**OS-IN-2020-014**

**Standardization ceramic panel design for OSRAM OSTAR®  
Projection Compact**

**Customer information package**

## 2. Description of change

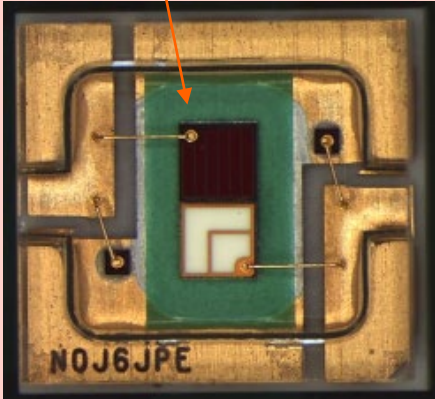
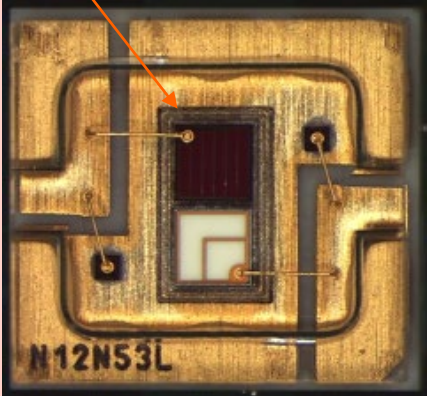
Current status	New status
<p data-bbox="282 582 788 625">With solder resist mask</p> 	<p data-bbox="1027 582 1707 682">Replace solder resist mask with laser scribe as solder stopper</p>
